Crystal River Nuclear Plant  
Docket No. 50-302  
Operating License No. DPR-72

Subject: Crystal River Unit 3 – Response to Request for Additional Information Related to  
Crystal River Unit 3 – Revised Appendix R Exemption Request – Fire Area CC-  
164-121

**RELATED TO CRYSTAL RIVER UNIT 3 – REVISED APPENDIX R  
EXEMPTION REQUEST - FIRE AREA CC-164-121**

Figure 6-1  
Equipment Arrangement  
Fire Area CC-164-121

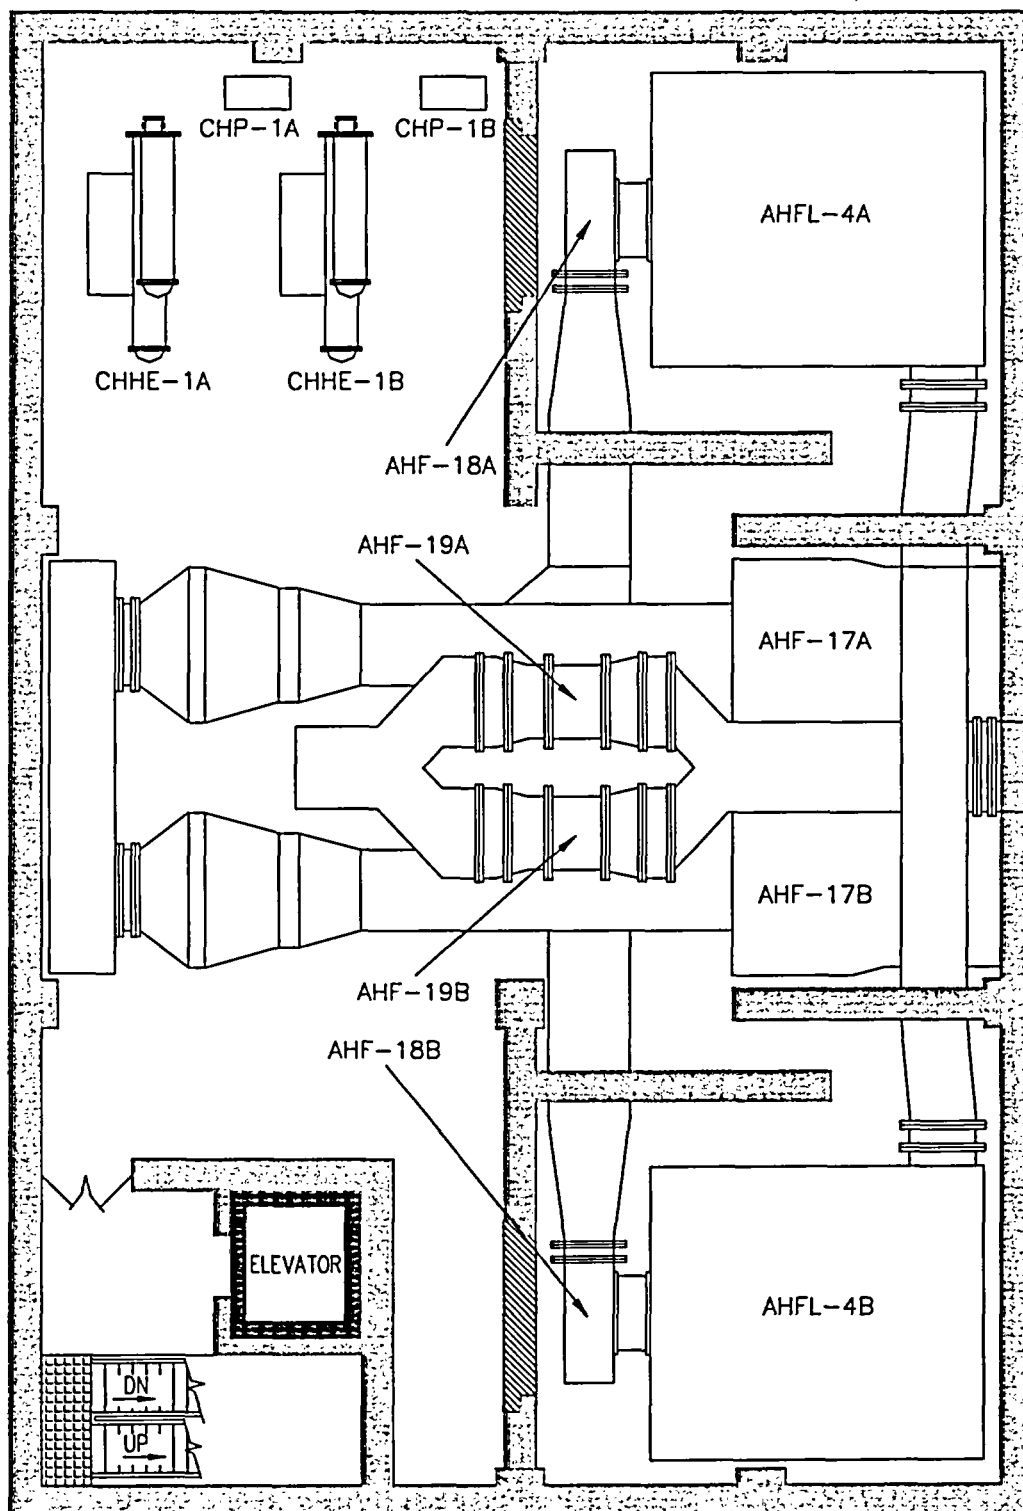
The interior walls of rooms 121 B and 121 C have 'hash marks' indicating some sort of opening. Provide a description of this opening.

The 2'-0" reinforced concrete walls separating Fire Zone CC-164-121A from Fire Zone CC-164-121C and Fire Zone CC-164-121D from Fire Zone CC-164-121B were installed during the construction phase of CR3. This is depicted on Reference 1, Attachment Figure 6-1, "Equipment Arrangement Fire Area CC-164-121," page 5 of 6 and included in this Attachment as Figure 6-1. From field inspection of these walls, it is apparent that the "hash marks" shown on Figure 6-1 are to denote a construction block-out that permitted installation of Fans AHF-18A and AHF-18B after placement of the walls. These block-outs were then filled with reinforced concrete after fan installation.

Figure 6-2  
Fire Zone Location  
Fire Area CC-164-121

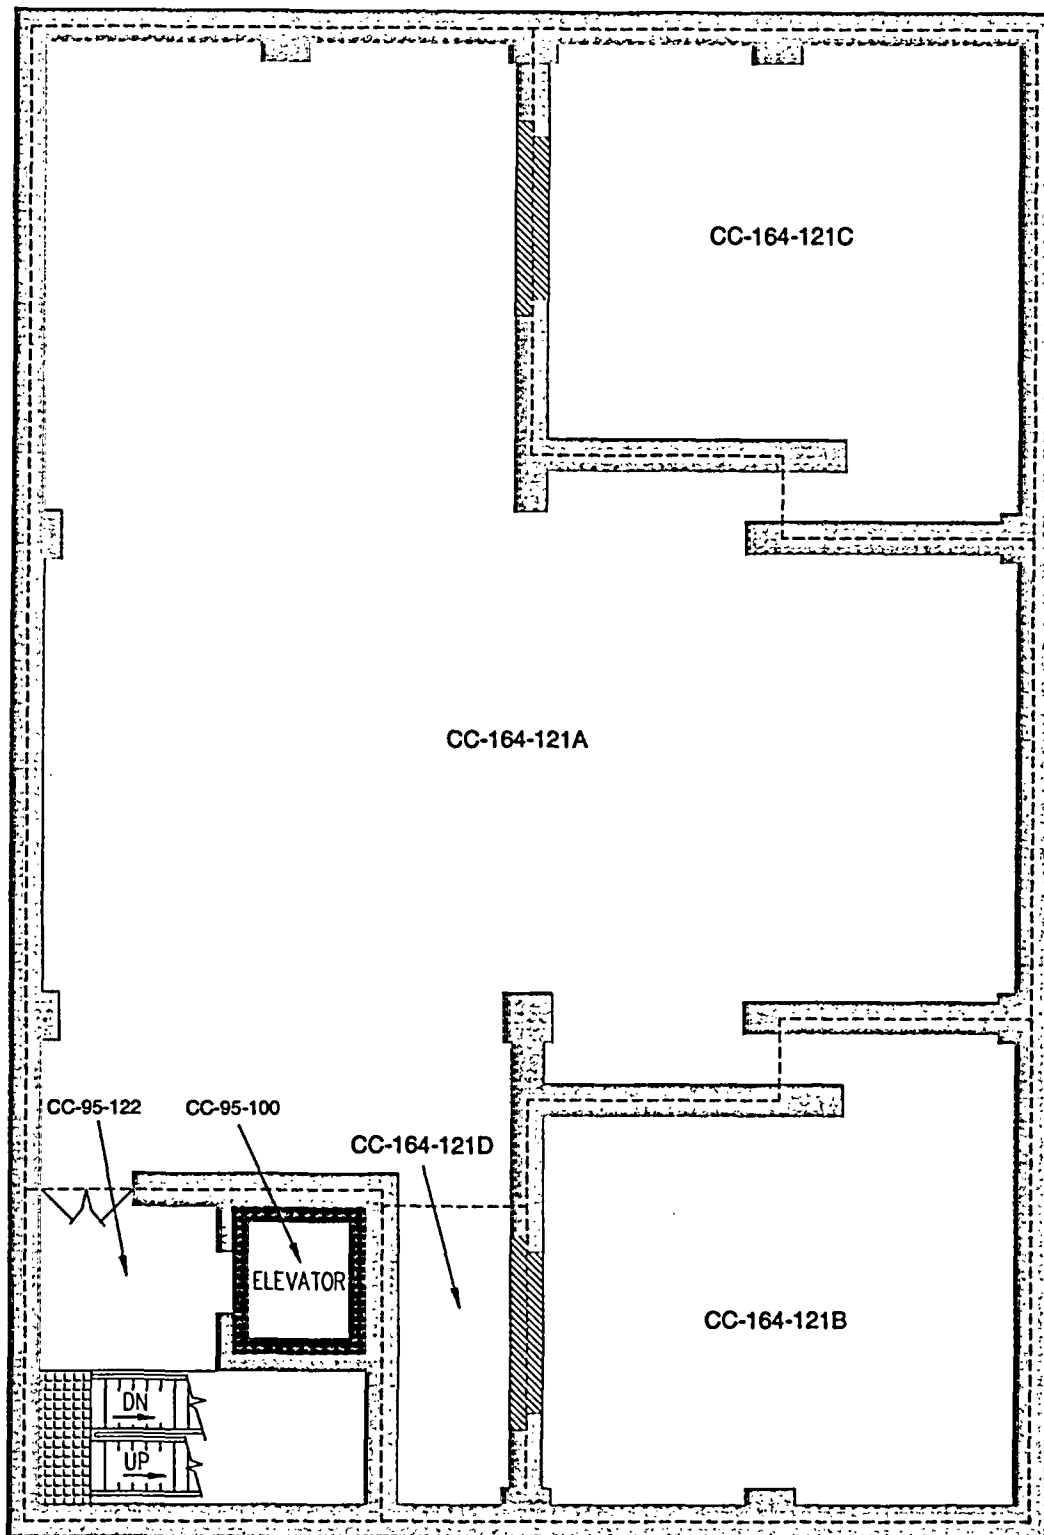
The local manual actuation is in the fire area containing the filter housings (Justification 2 of 10). Provide an analysis that fire conditions would be contained within the filter housing (i.e., capability to withstand a 1.7-hour ASTM E-119 fire). Describe where within the area the local manual actuation stations are located. State whether the fire brigade has been trained in the operation of these systems in the event that the fire area is filled with smoke.

The local manual actuation is in the same fire area containing the filter housings (Fire Area CC-164-121) but not in the same fire zone. The local manual actuations are in Fire Zone CC-164-121 A and the filter housings are in Fire Zones CC-164-121 B and CC-164-121C. The filter housings were not designed to withstand a 1.7-hour ASTM E-119 fire so such an analysis does not exist. If fire conditions were not contained within the filter housing, conditions that may occur in Fire Area CC-164-121 include heat and toxic atmosphere (e.g., smoke and other products of combustion). As noted below, the Fire Brigade is trained in accessing fire areas and successfully completing operation of equipment in situations like this.

Fire Area CC-164-121 is the Control Complex HVAC area and is divided into four fire zones: CC-164-121A, 121B, 121C, and 121D. The area extends from the 163' 10" elevation to the 186' 10" elevation and is depicted on Reference 1, Attachment Figure 6-2, "Fire Zone Location, Fire Area CC-164-121," page 6 of 6 and included in this Attachment as Figure 6-2. The local manual actuation of the charcoal filter fixed water spray systems would be performed in Fire Zone CC-164-121A along the wall bordering Fire Zone CC-164-121C near the "hash marks." This zone is separated from Fire Zones CC-164-121B and CC-164-121C containing the charcoal filter housings by heavy monolithic concrete construction. Although these walls are not considered rated, such walls have substantial fire resistive capability.
